SI B17 01 13  
Cooling Systems

September 2013  
Technical Service

**Service Action: Replace Coolant Expansion Tank**

F30

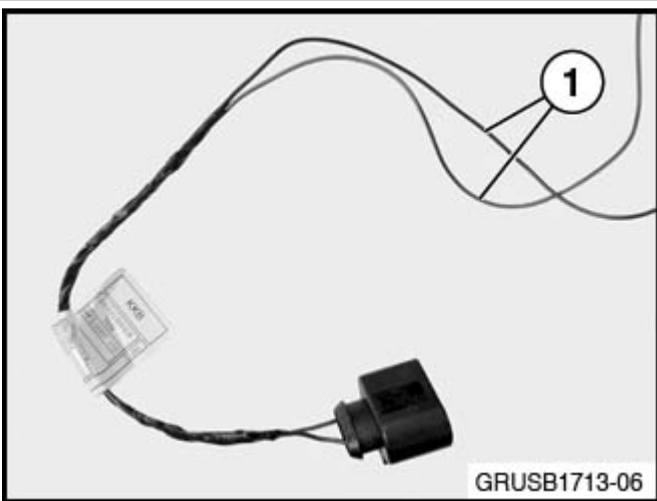
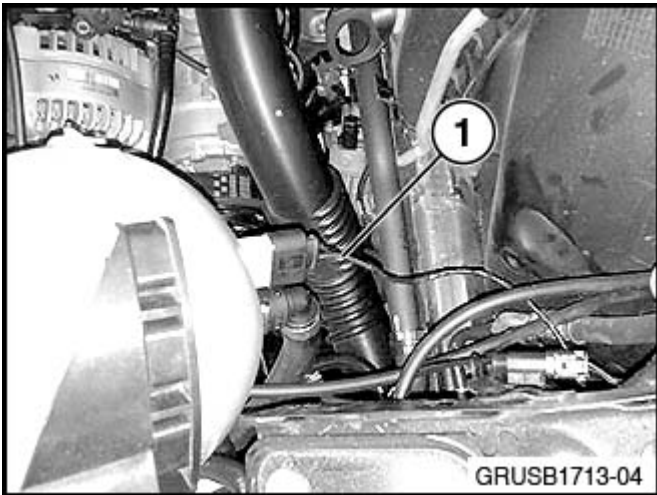
\*Note: Check for proper connection of the lower coolant hose from the expansion tank when removing/replacing the tank (1). The coolant hose may become disconnected during repairs. The hose will contact the engine cooling fan if this hose remains disconnected from the bracket. (Air box removed for clarity.)

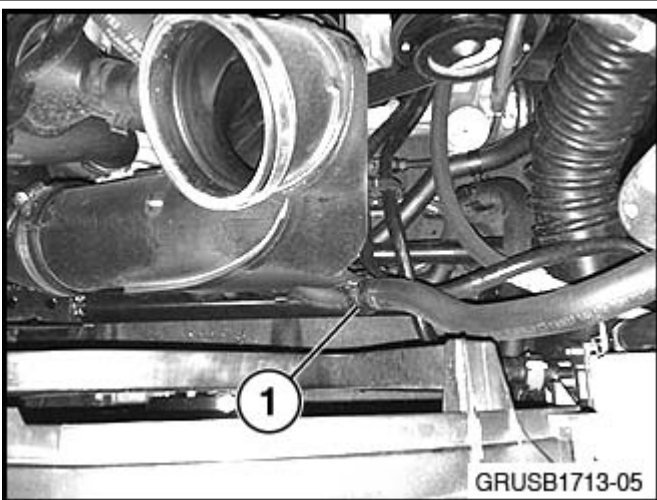
<p>Cut the wiring on the old connector for the coolant level sensor at 5 mm from the connector (1).</p>
--	---

Cut the replacement harness (from connector repair kit P/N 61 11 9 312 324) at 50 mm away from the taped portion of the harness (1). Crimp the new level sensor harness to the body harness with the provided cable connectors and heat shrinking hose (Refer to Repair Instruction 61 13 ... Butt connector for repairing a plug connection). Install the new coolant expansion tank.
